### APPEAL SUMMARY

<b>Appeal ID:</b> 15939	<b>Project Address:</b> 300 NW 8th Ave
<b>Hearing Date:</b> 10/11/17	<b>Appellant Name:</b> Robert Hayden
<b>Case No.:</b> B-002	<b>Appellant Phone:</b> 503-680-1087
<b>Appeal Type:</b> Building	<b>Plans Examiner/Inspector:</b> Natalie Davis
<b>Project Type:</b> commercial	<b>Stories:</b> 11 <b>Occupancy:</b> R-1, B, S-3 <b>Construction Type:</b> Type I
<b>Building/Business Name:</b>	<b>Fire Sprinklers:</b> Yes - units and corridors
<b>Appeal Involves:</b> Reconsideration of appeal	<b>LUR or Permit Application No.:</b> 16-269455-CO
<b>Plan Submitted Option:</b> pdf [File 1]	<b>Proposed use:</b> Mixed-use residential/apartments

north park lofts - exterior gate addition

# Project: North Park Lofts - Gate

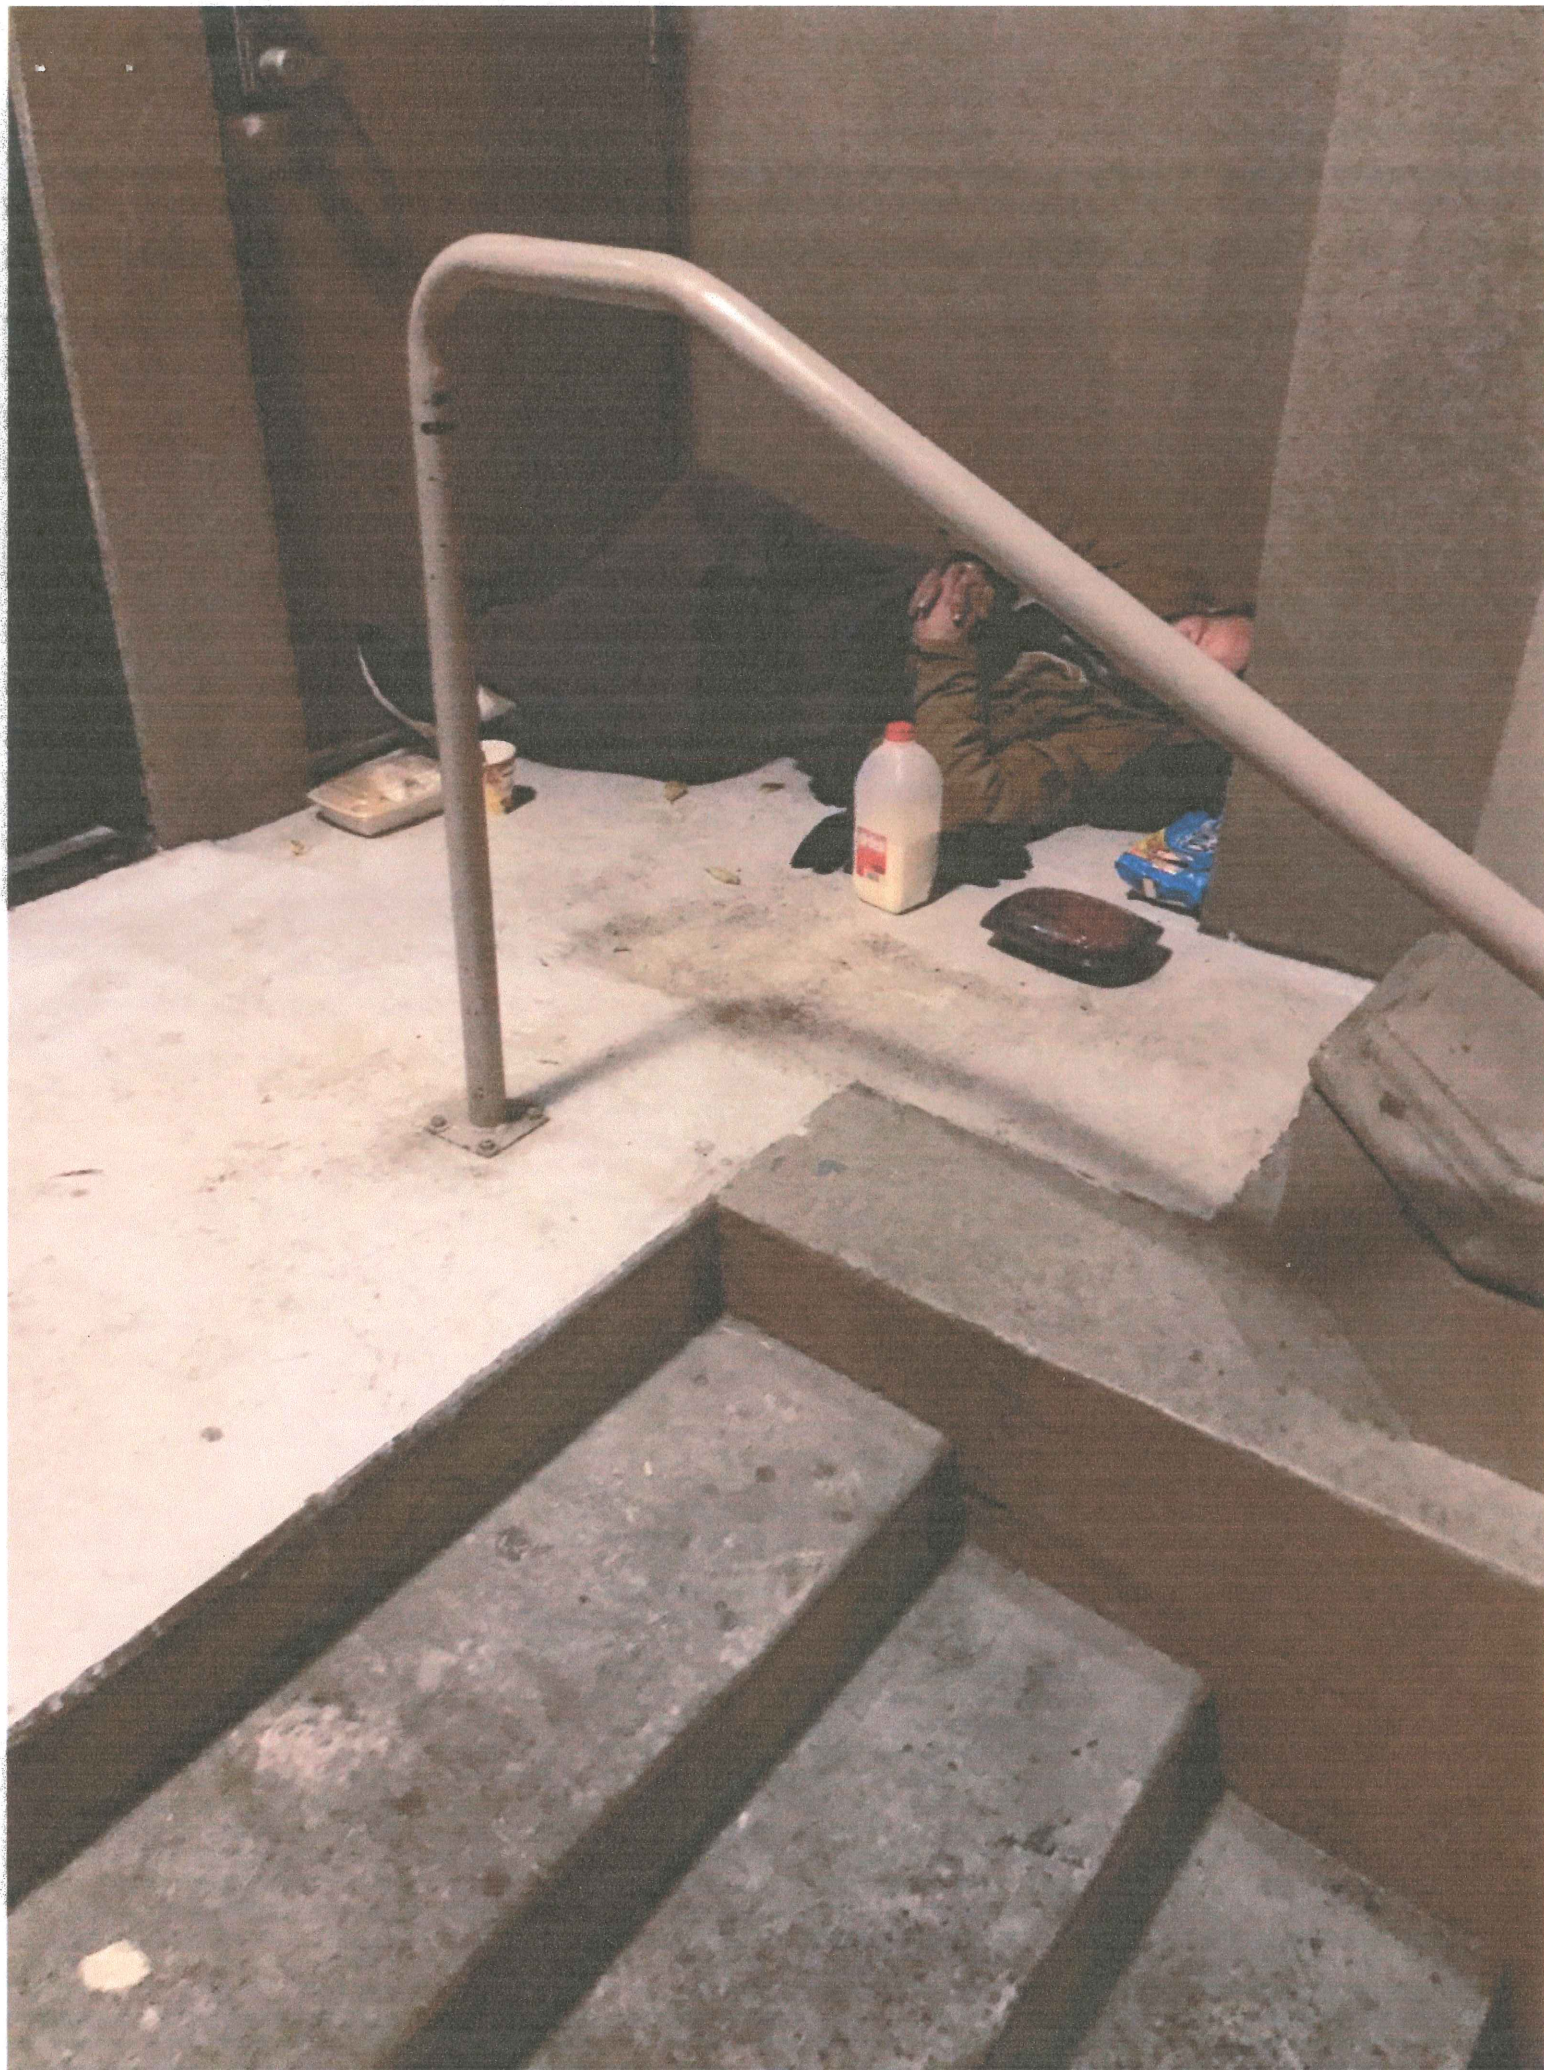
This gate will allow for a safer egress path from the building than currently exists. Currently, there are people that sleep on this upper landing. and often in front of the egress door (see attached photos). This provides for a very unsafe situation, and especially unsafe in the event of an emergency. This gate will help to correct that situation, keeping the egress path clear.

## STAIR & LANDING PLAN

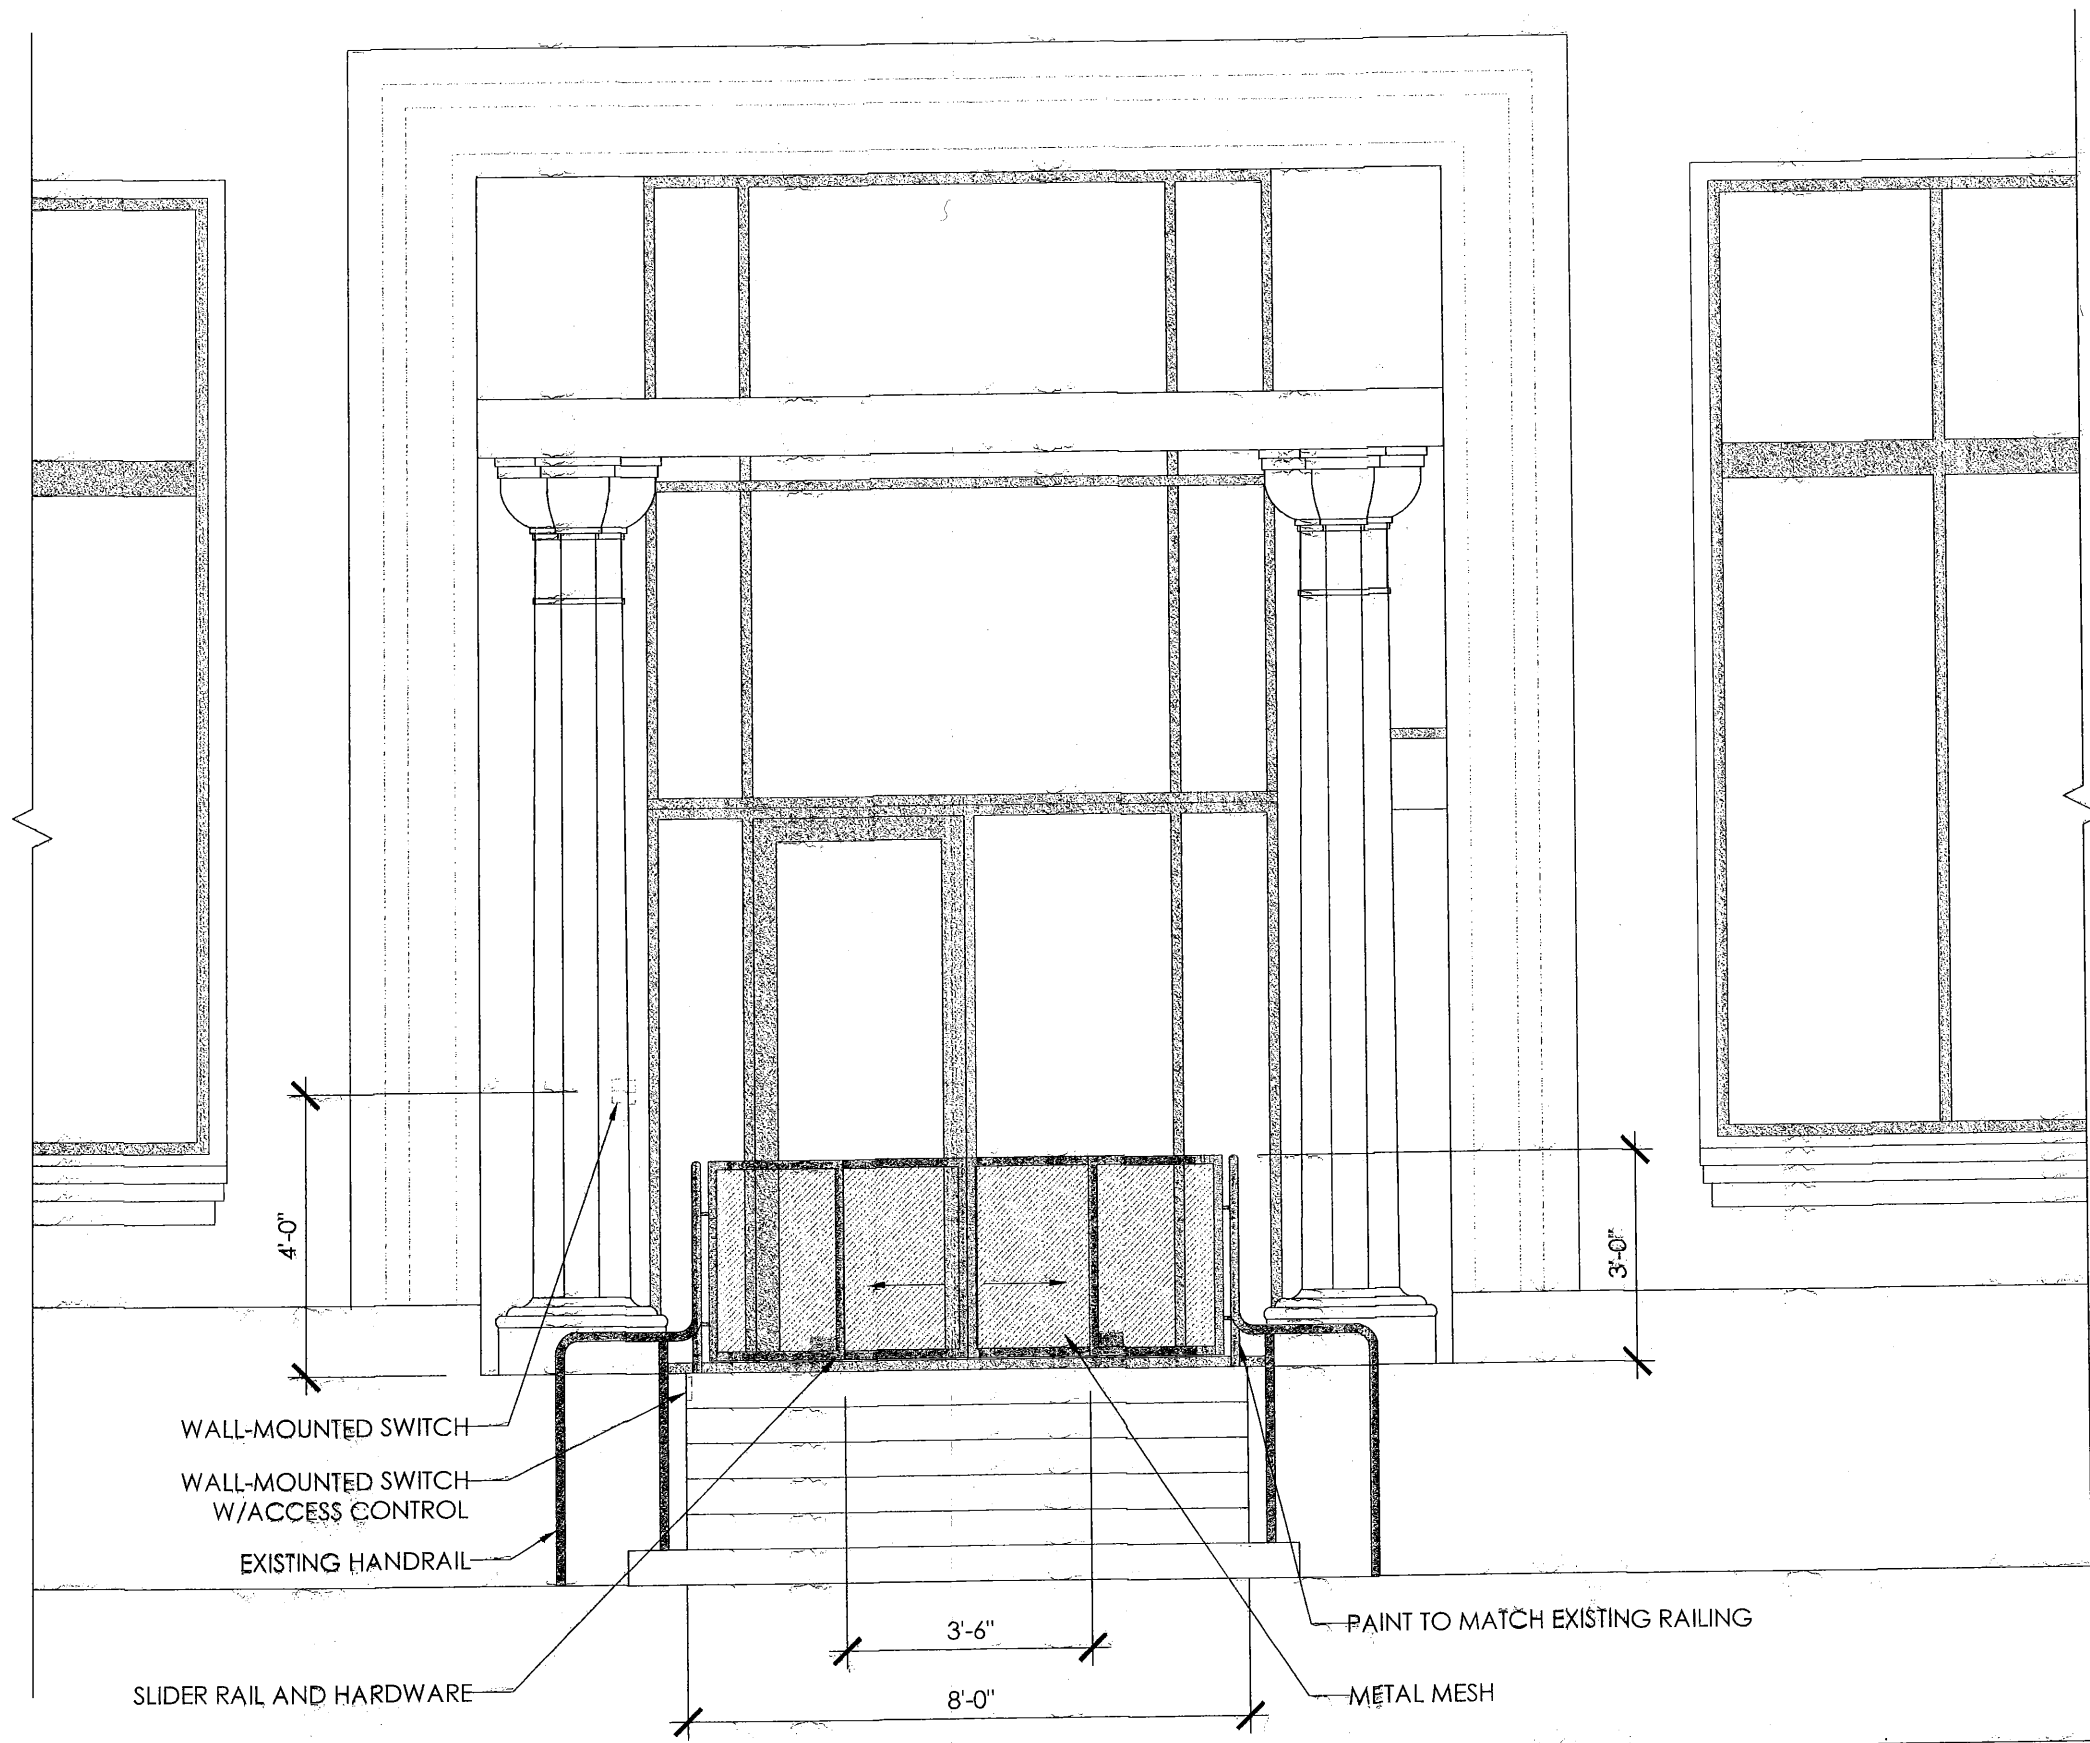
<b>Reason for alternative</b>	We are appealing the need for a landing on one side of this door. There is an adequate landing at the top of the stairs. There is no landing for the door on the entry side, but all of the operation required to open the gate from that side occurs at the bottom of the stairs, before someone continues up the stairs, which would replace the need for any manual operation at the gate itself. The automatic power-operated system will trigger the gate opening when the fire exit does. This hardware will detect when contact is broken by the door opening, opening the gate and ensuring that there will not be any obstacle at the gate threshold itself. By the time they encounter the gate,

it will be fully open. This will allow for a completely unobstructed egress path. No one should need to operate the door while on the stairs.

**Sliding gate at egress stairway with no landing between the top step and gate: Denied. Proposal does not provide equivalent Life Safety Protection.**
